South Texas Project Electric Generating Station P.O. Box 289 Wadsworth, Texas 77483

December 18, 2003
NOC-AE-03001650
10CFR50.90

South Texas Project
Unit 2
Docket No. STN 50-499
Supplement 1 to Proposed Emergency Change to Technical Specification 3.8.1.1

Response to Request for Additional Information

Figure 1

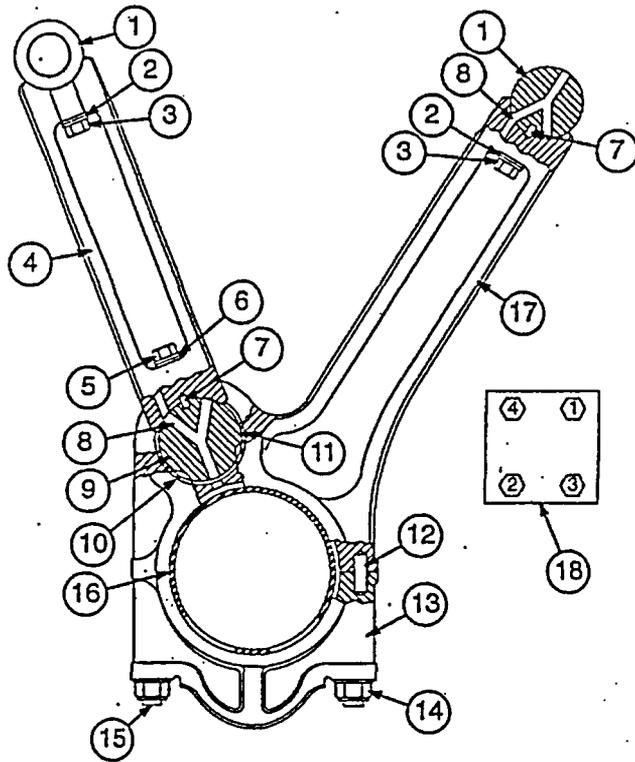
1. Please identify the root cause of the December 9, 2003 failure of SDG 22.**Response:**

The root cause of the diesel engine failure is microcracks created on the position 9 master connecting rod during manufacturing that propagated due to high cycle fatigue until the master connecting rod failed.

A typical connecting rod in the South Texas Project (STP) standby diesel generator (SDG) engine is shown in Figure 1. The articulated connecting rod is on the left and the master connecting rod is on the right. Each piston position in the diesel engine consists of a left (L) bank piston utilizing the articulated connecting rod and a right (R) bank piston utilizing the master connecting rod.
